UNITED STATES PATENT AND TRADEMARK OFFICE
CERTIFICATE OF CORRECTION

PATENT NO. : 6,999,652 B2
APPLICATION NO. : 10/675391
DATED : February 14, 2006
INVENTOR(S) : Mino et al.

FIG.3A
PRIOR ART

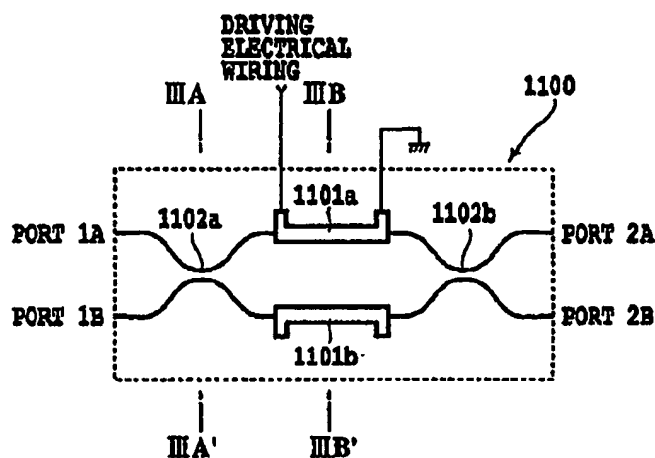
Sheet 3, replace Figure 3A as shown below to change mislabeled reference number "C00" to --1100--
